NEW YORK CITY DEPARTMENT OF CORRECTION

**ADDENDUM #4 PIN 072202009CPD**

**George R. Vierno Center (GRVC) State of Good Repair**

**DESCRIPTION OF CHANGES**

A-411.00

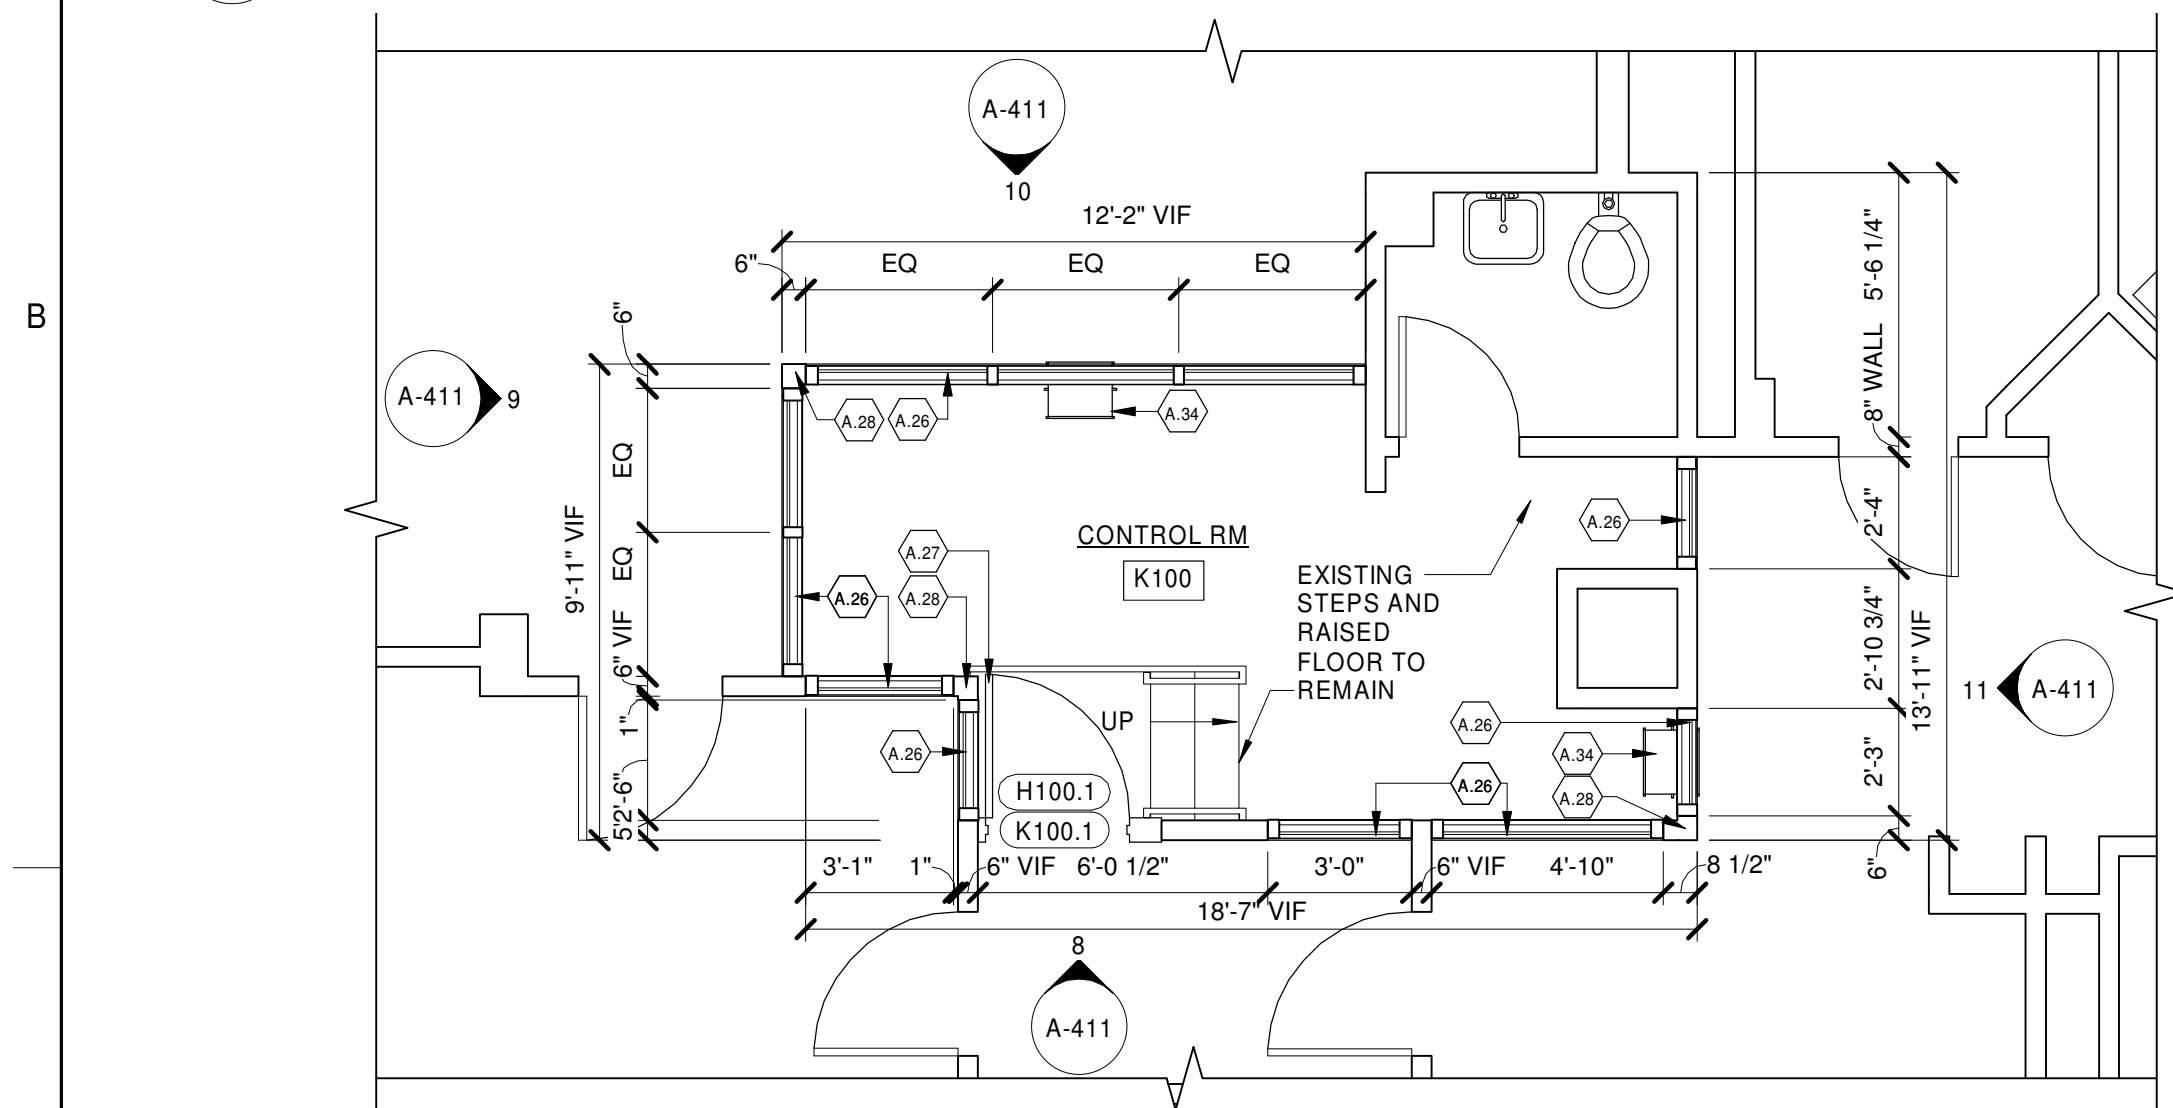
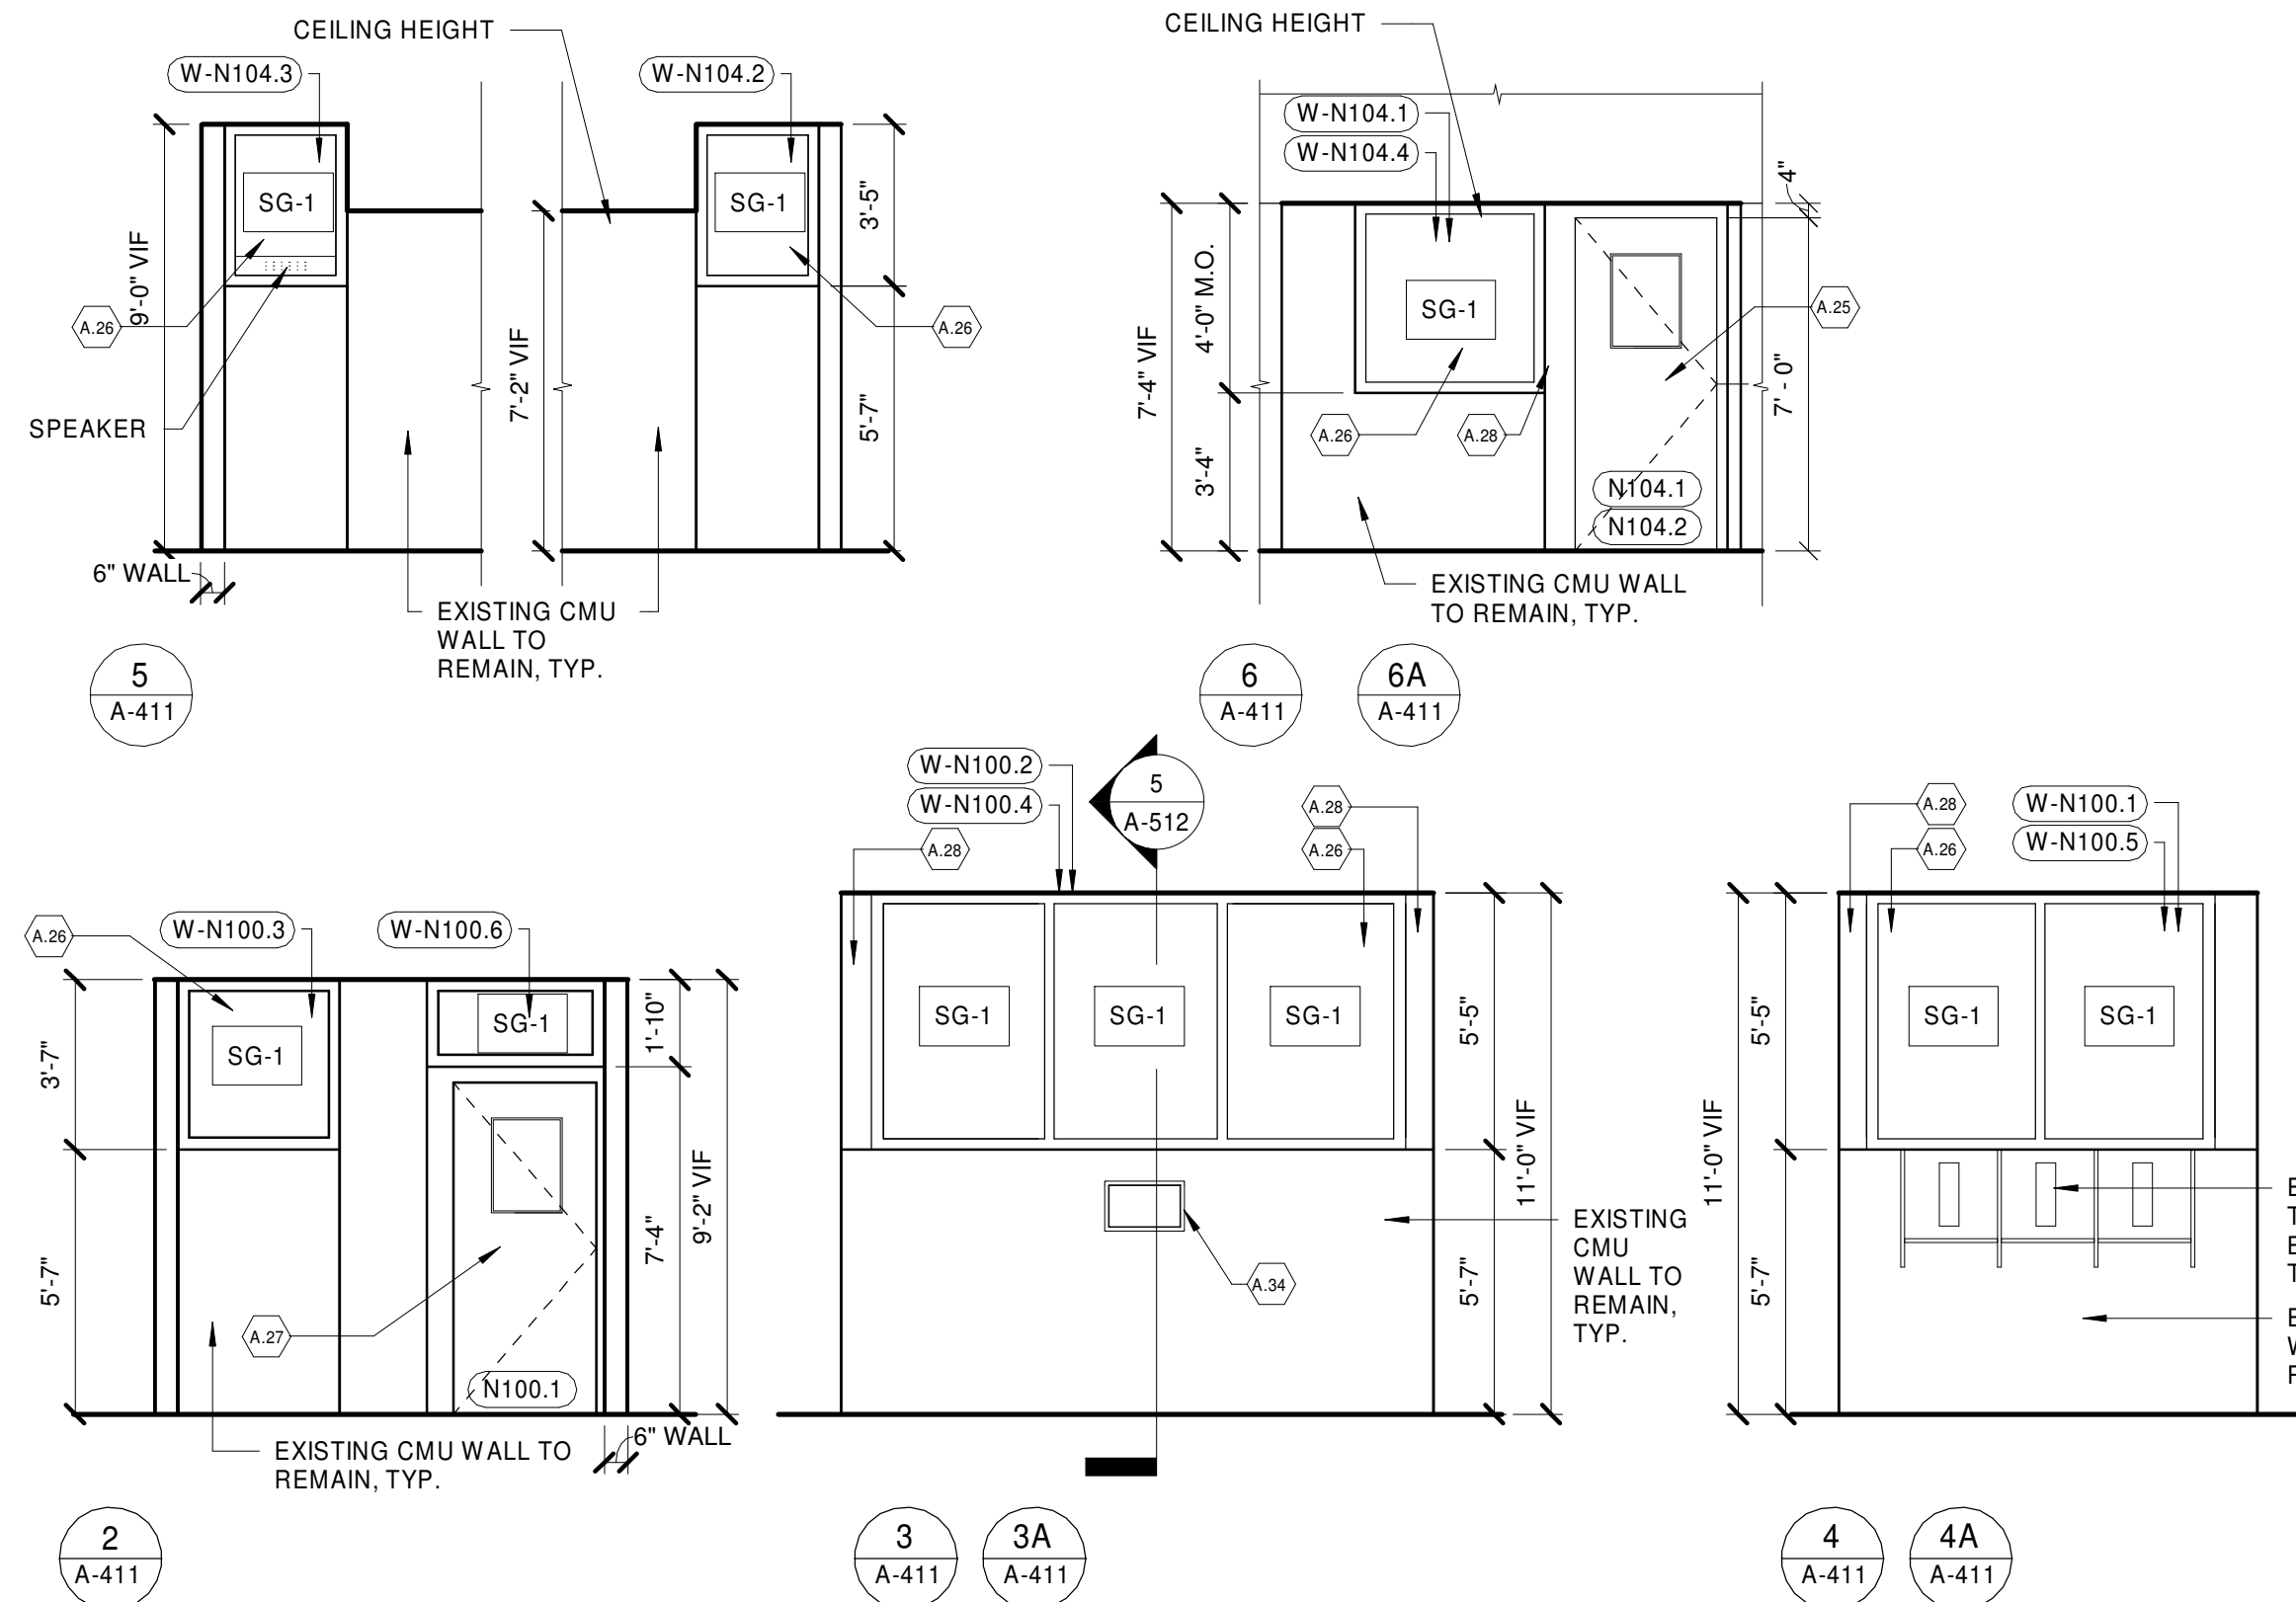
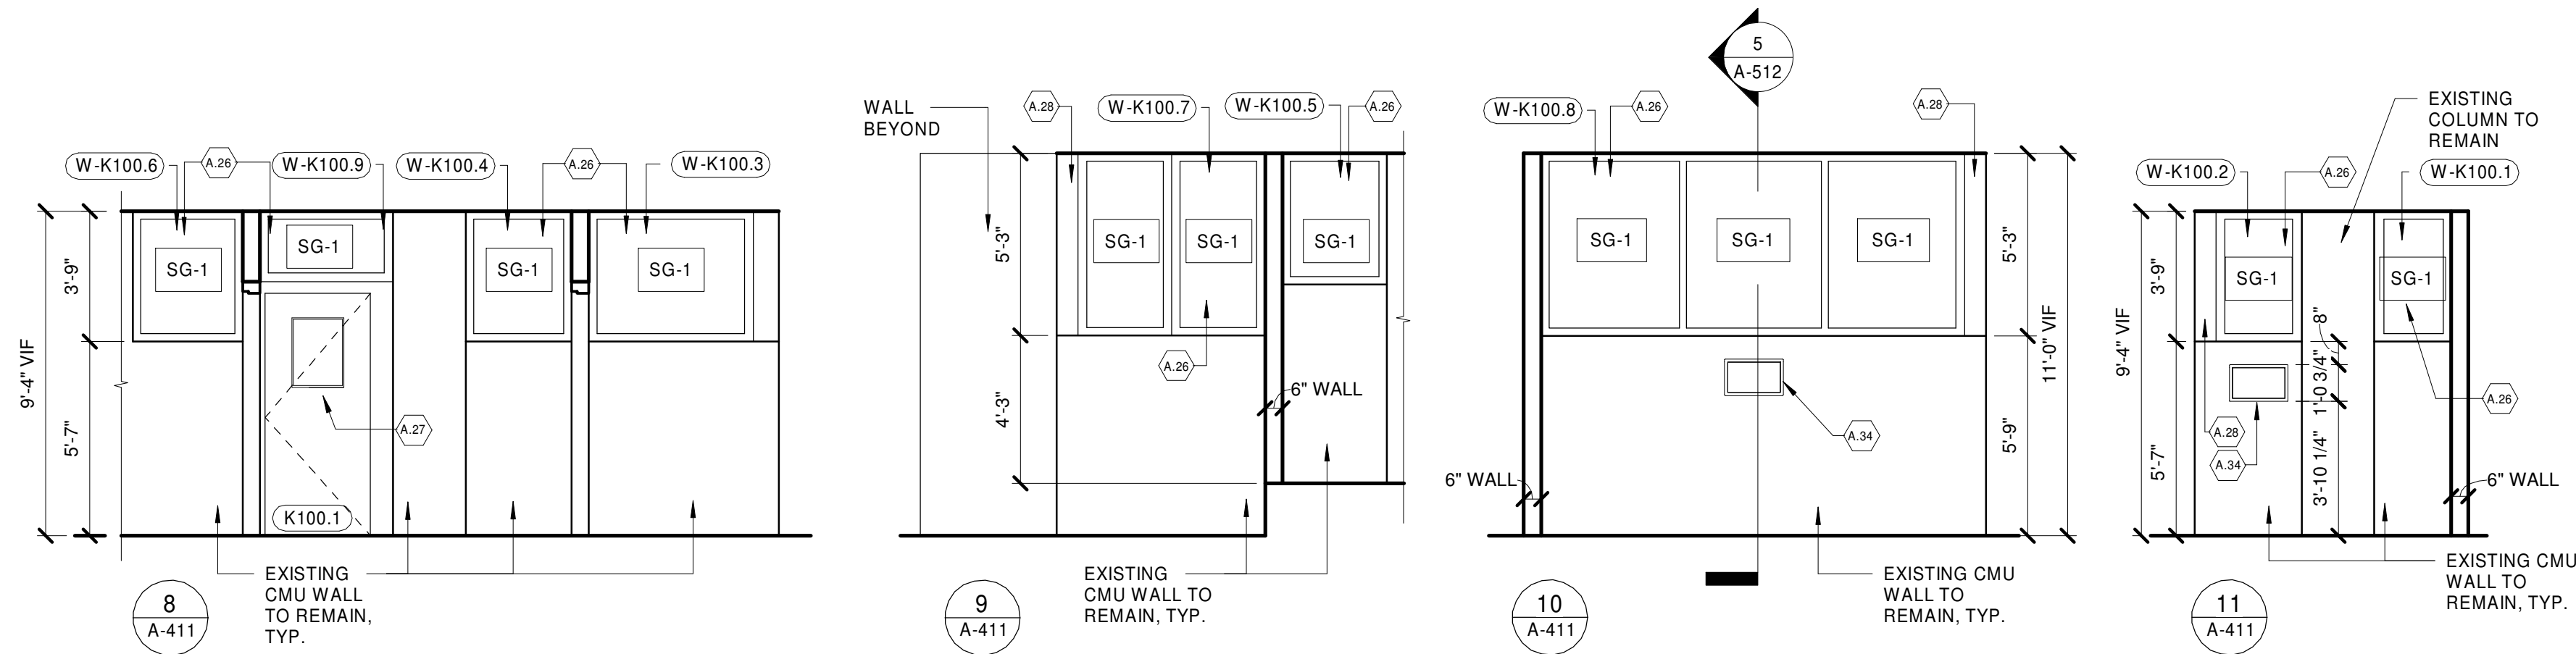
3. **A-320.00:** Added Mesh Infill Panels at the Roof Guardrail on the Parapet Sections.
4. **A-411.00:** Revised Keynote #A.26.
5. **A-412.00:** Revised Keynote #A.26.
